No. L.S. 548 of 1919.

With reference to their application dated 21st Instant with plan for the proposed additions on plot No. 18, K-9 Lyari Quarter Messrs Sabatkhan and Izatkhan sons of Madatkhan are informed that :-

NOTICE UNDER SECTION 96 OF ACT III OF 1901.

I beg to inform you that I intend building additions
on plot No. 18

— GROUND PLAN —

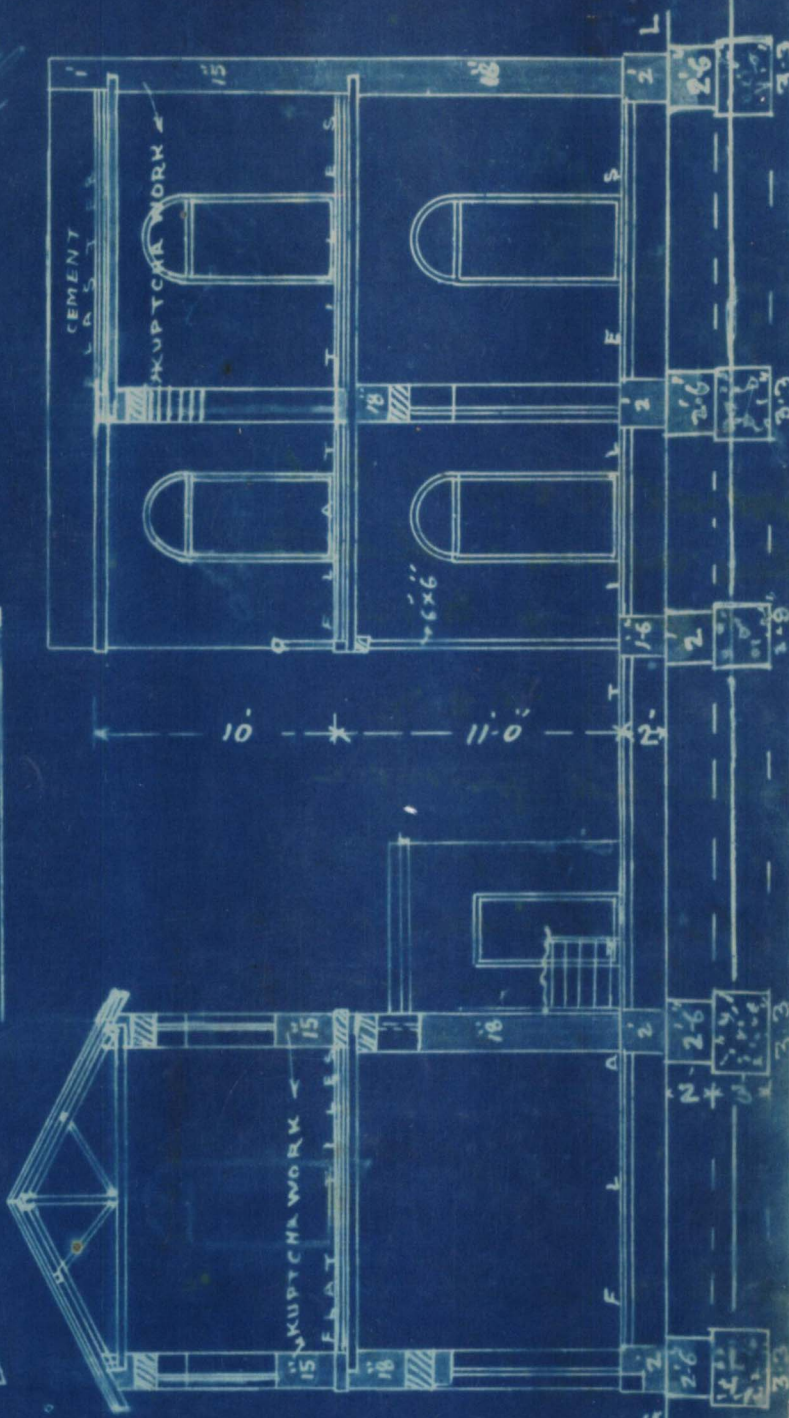
sectional plan of
the privies is not
complete. The
applicant must
show the soil pipe
coming down & the
site for the receptacle
for eff. flow privy

Reply that he is attempting
to overcramp the plot.
Before any building
can be allowed on the
1st floor he must re-
move the kitchen, privy
&c on the ground floor
which make the shops
unsuitable & provide
block by suitable
convenience to the
North of the compound.
If he sends or brings
his architect to this
office a suitable
building arrangement
will be explained to
him in detail.
The plans are returned
disapproved.

1. Back to back rooms will not be permitted.
2. Adequate sanitary conveniences and kitchens are not provide
3. The plot will be overcrowded.

*Sanitary conveniences &
kitchens are not adequately
provided*

Building Surveyor's report Sir with reference to this I beg to
 report that Sanitary Conveniences & Kitchens are not
 adequately provided.

Remarks Sir With reference to this I beg to report
 that now the applicant proposes to put up
 an upper story on the ground floor which encroaches
 the open space in adequate and the conveyance
 on the open space should not be allowed.

— PLAN OF PROPOSED FIRST FLOOR TO BE —

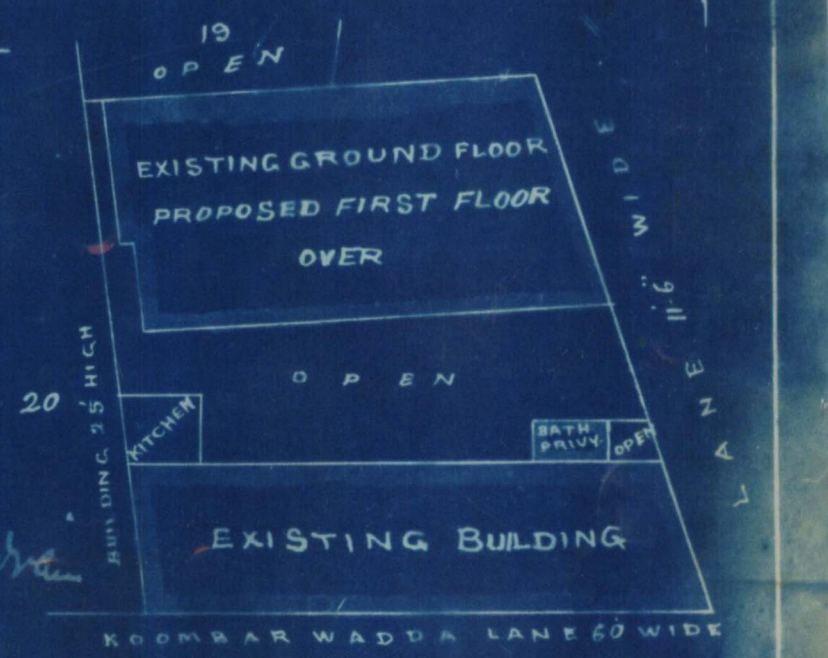
With reference to their application dated 21st ultime with plan for the proposed additions and alterations on plot No. 18, K-9 Lyari Quarter Messrs Sabat Khan Izat Khan sons of Madat Khan owners of the above plot are informed that they are attempting to overcrowd the plot.

Before any more buildings can be allowed on the first floor they must remove the kitchen privy etc: on the ground floor which make the shops insanitary and provide a block of suitable conveniences to the north of the compound. If they send or bring their architect to this office a suitable building arrangement will be explained to them in detail.
